# CORDLESS DRIVER DRILL

**Model 6095D**  
**Model 6095DQ\***  
**Model 6095DW**  
**Model 6095DWE**  
**Model 6095DWBE**  
(MJ/MCA/MME/MCP)  
**Model 6095DWL-2**

**02-2001**  
**6095DQ\* Discontinued in 1992**

## SERVICE CHANGES

### 1. Change on Spur Gear, Steel Ball & Clutch Cam.

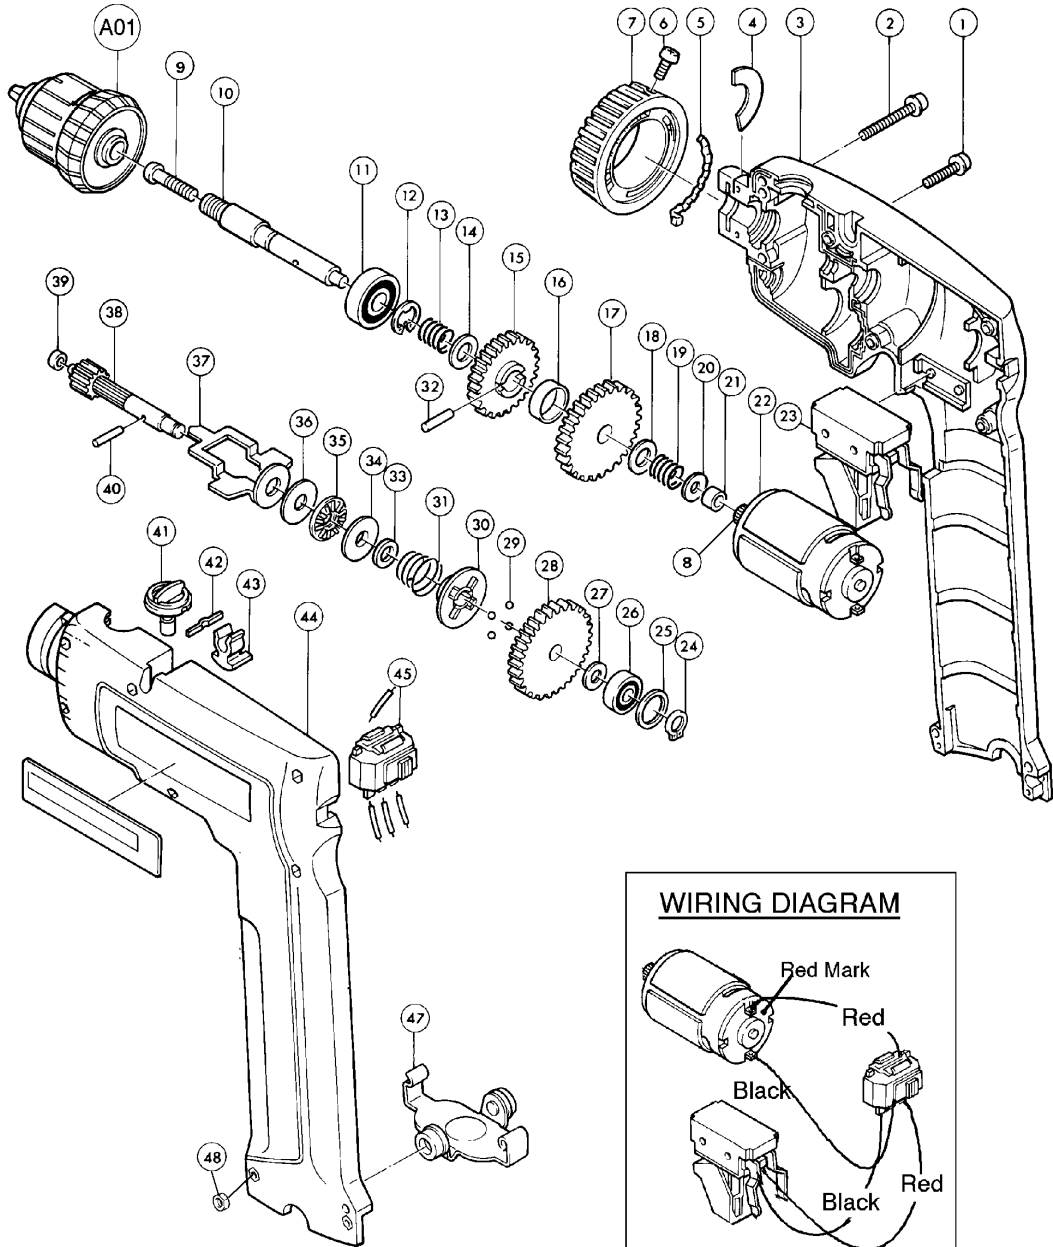
Item No.	Description	Type 1	Type 2
28	Spur Gear 89	221883-7	226233-1
29	Steel Ball	216002-8 (4.8)	216011-7 (5.6)
30	Clutch Cam	223059-2	223086-9
	Serial No. 6095D	~ 500353E	500354E ~
	Serial No. 6095DW	~ 34715E	34716E ~

### 2. Change on Housing.

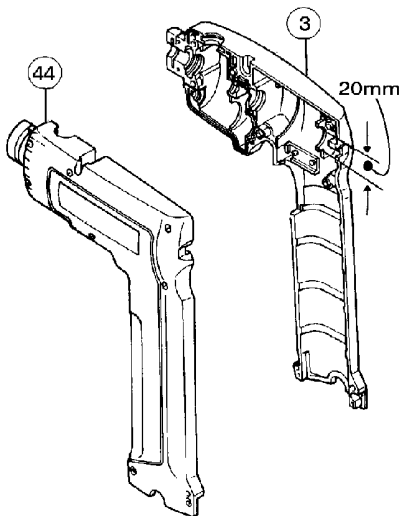
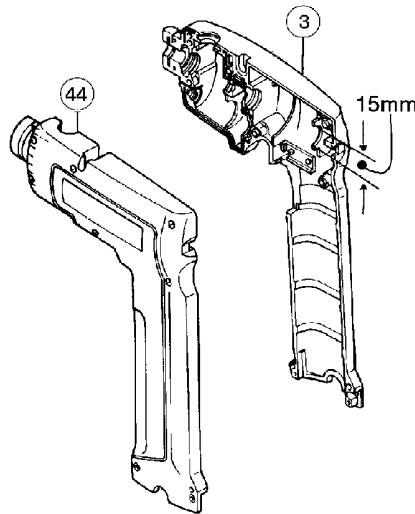
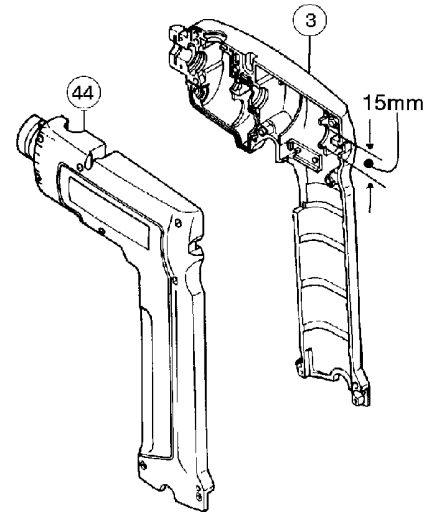
Item No.	Description	Type 1 (MJ)	Type 2 (MME)	Type 3 (MCP)
3	Housing (R)	414391-7 (No Longer Available)	415007-7	<b>183055-1</b> Set (415007-7A)
44	Housing (L)	414392-5 (No Longer Available)	415008-5	<b>183055-1</b> Set (415008-5A)
